Triple Apparels Ltd.

24th September 2020

1. Main Factory Building (Existing G+2, Proposed G+5)
2. Utility Building (Existing B+G+1, Proposed B+G+2)
3. Substation Building (single storied)

Observations

**Prepared design report required to
be revised**

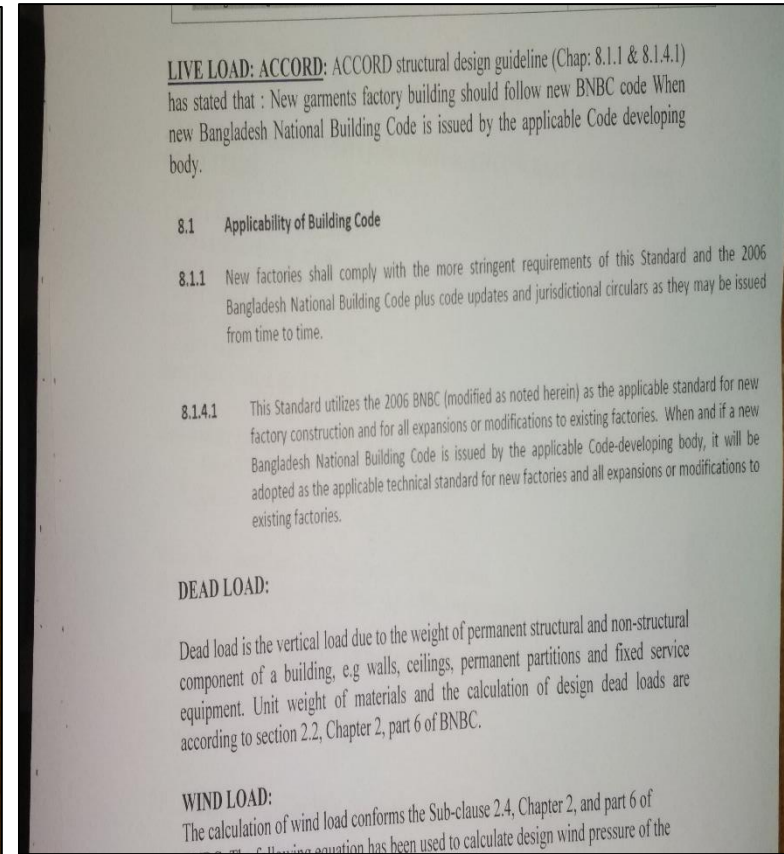
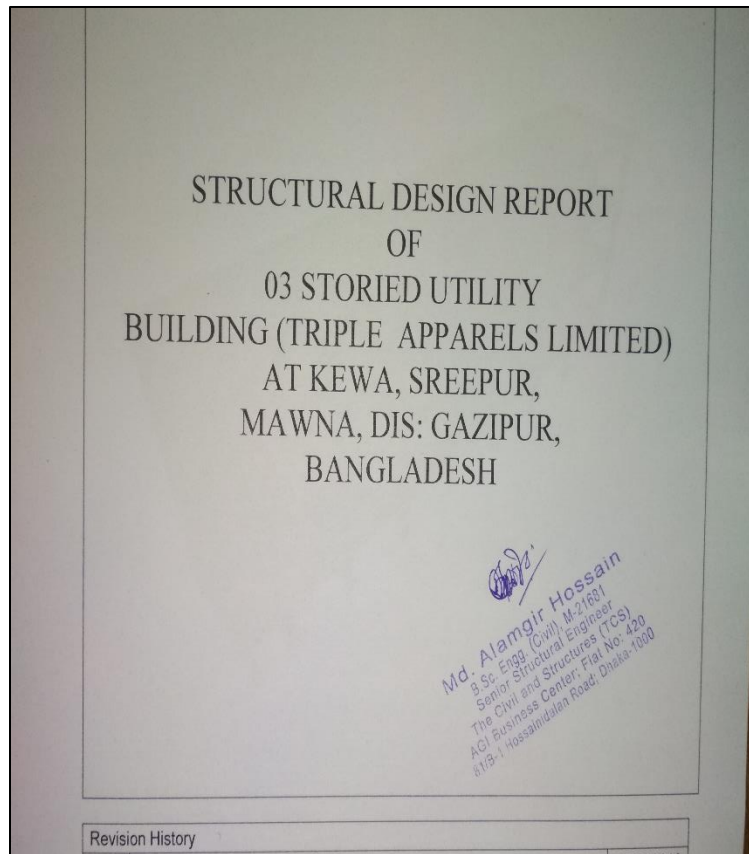
This building is permitted for 6 (G+5) storied from local authority. Currently, the building is partial 3 storied. Factory has provided a proposed drawings and design report for six storied building.

Shear wall adequacy check was not provided in the design report. Also, No irregularity check was provided in the design report. Incorporate all kinds of irregularity (Torsional, mass, Diaphragm Discontinuity, stiffness, etc.) check in design report according to BNBC.

Item No.	Observation	Recommended Action Plan	Recommended Timeline
01	Prepared design report required to be revised.	Factory is required to check the adequacy of shear wall and incorporate all kinds of irregularity (Torsional, mass, diaphragm discontinuity, stiffness, etc.) check in design report according to BNBC.	6-weeks
02	Prepared design report required to be revised.	Produce and actively manage a loading plan for all floor plates within the factory, considering floor, column and foundation capacity.	6-weeks
03	Prepared design report required to be revised.	Complete implementation of any remedial works deemed necessary by the design report.	6-months
04	Prepared design report required to be revised.	Continue to implement loading plan.	6-months
05	Improper drainage and stacking of construction material on existing roof.	Factory is required to improve the water drainage system to avoid water clogging in future.	6-weeks

Incomplete as-built drawings of external steel stair

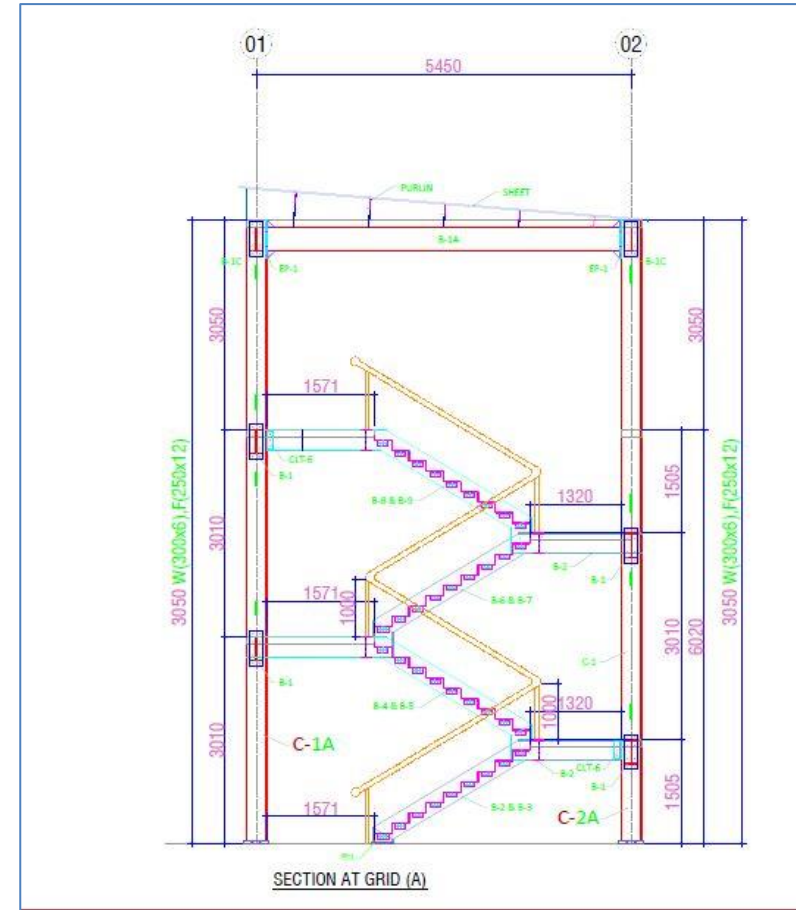
During inspection, flange width of steel column was found 240 mm instead of 250 mm. On the other hand, connection details were not found in provided drawings.

Item No.	Observation	Recommended Action Plan	Recommended Timeline
07	Incomplete Design Report.	Factory Engineer is required to complete design report as per BNBC Part 6 Sec 1.9.1.1 requirements and submit for review along with other relevant documents.	6-weeks
08	Incomplete Design Report.	Produce and actively manage a loading plan for all floor plates within the factory, considering floor, column and foundation capacity.	6-weeks
09	Incomplete Design Report.	Complete remedial works if arising from design report after reviewed by RSC.	6-months
10	Incomplete Design Report.	Implement floor loading plan after getting acceptance.	6-months
11	Corroded and exposed rebar at roof.	All exposed reinforcement is to be protected from corrosion which may cause degradation of the concrete.	6-weeks
12	Incomplete as-built drawings of external steel stair.	Prepare “as constructed” drawings which reflect the actual site dimensions and provide connection details with complete structural information.	6-weeks
